SERVICETEKNOTES

TABLE OF CONTENTS

Figure 1.

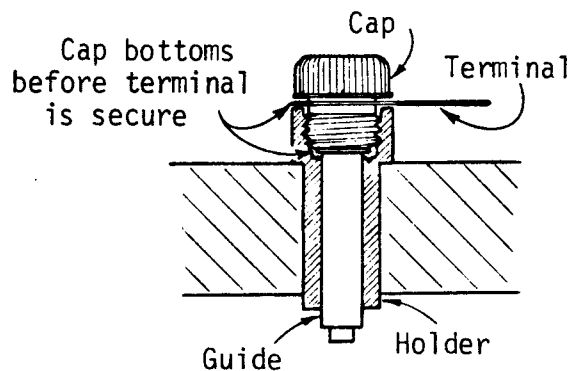
The 147-0039-0X motor is used in the 4631, 4632, 4634 and 4635 copiers, imagers and recorders. The vendor who supplies these motors has recently changed the design of the brush holders. Early brush holders were machined from red plastic-covered brass slugs. The newer holders are made of black molded plastic and have a square brass insert which acts as the brush guide.

A problem has been seen on some of these new holders. The cap may bottom out within the holder before the hook-shaped terminal is secured (see figure 1). This poor connection may result in erratic motor speed and random cutter actuation. While tightening the cap to secure the terminal, the overzealous specialist (ARTICLE CONTINUED ON THE NEXT PAGE)

may break the cap, shear off the top of the holder or rotate the holder. If the holder is rotated, damage will occur on power up as the brush cuts into the armature.

The vendor is remedying the problem by using a shorter cap and recessing the brass guide. The field may wish to shim the brush cap using a 210-0012-00 lock washer (see figure 2). This will be necessary as some "defective" motors were shipped prior to discovery of the problem. Lot codes that are particularly suspect are HW, JW, KW and LW.

Figure 1

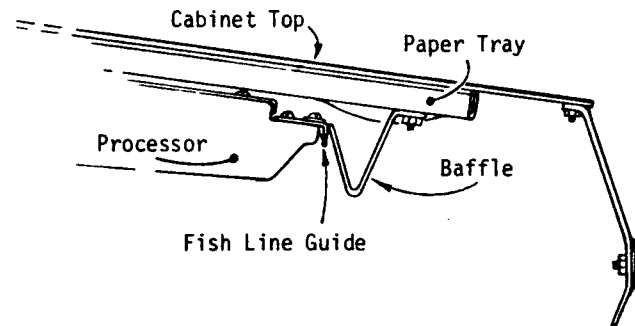
When replacing processors in the 4631 and 4632 hard copy units, it is important to compare the lengths of the

fishline paper guides between the old and new processors. If an earlier, shorter chrome guide (P/N 351-0378-00) is being replaced by a newer, longer black guide (P/N 351-0582-00), two problems are possible.

First, if the baffle in the top cover rubs against the fishline guide, eventual breakage of the fishline will result. Second, when the cover is closed to set the switch panel height for no light leaks, the baffle may catch under the new, longer paper guide. The cover may now be locked in place and not removed without damage to either the baffle, the paper guide, or both.

The solution is to use caution when closing the cover on a new processor for the first time. With the switch panel lowered to present the worst case, slowly lower the cabinet top. At the first hint of binding between the paper guide and the baffle, the cover should be raised and the baffle bent slightly to prevent interference. Continue in this manner until it is certain that the baffle and paper guide won't interfere. Then, set the switch panel for the correct height.
